# Safety Evaluation Report

Related to the License Renewal of  
the Joseph M. Farley Nuclear Plant,  
Units 1 and 2

Docket Nos. 50-348 and 50-364

### Trend lines for the hoop tendons

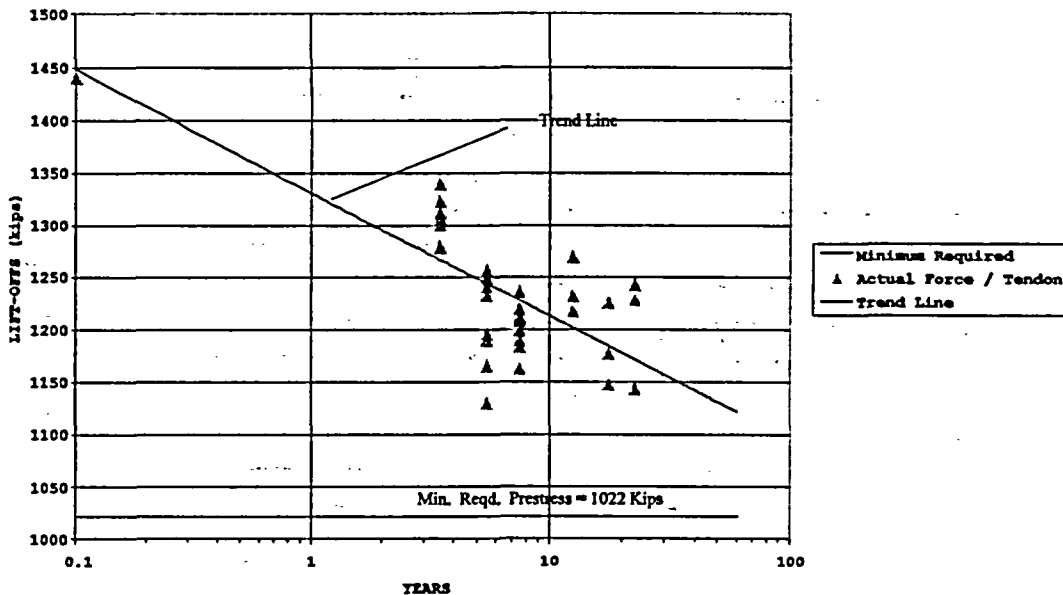
- (a) The following are the minimum required prestressing forces per tendon (170 wires/tendon):

Hoop Tendon = 1021.7 kips/Tendon  
Dome Tendon = 1079.5 kips/Tendon  
Vertical Tendon = 1157.7 kips/Tendon

In response to (b) and (c), the applicant provided the trend lines for the hoop, vertical, and dome tendons in graphical and tabular form. This information is as follows for the hoop tendons:
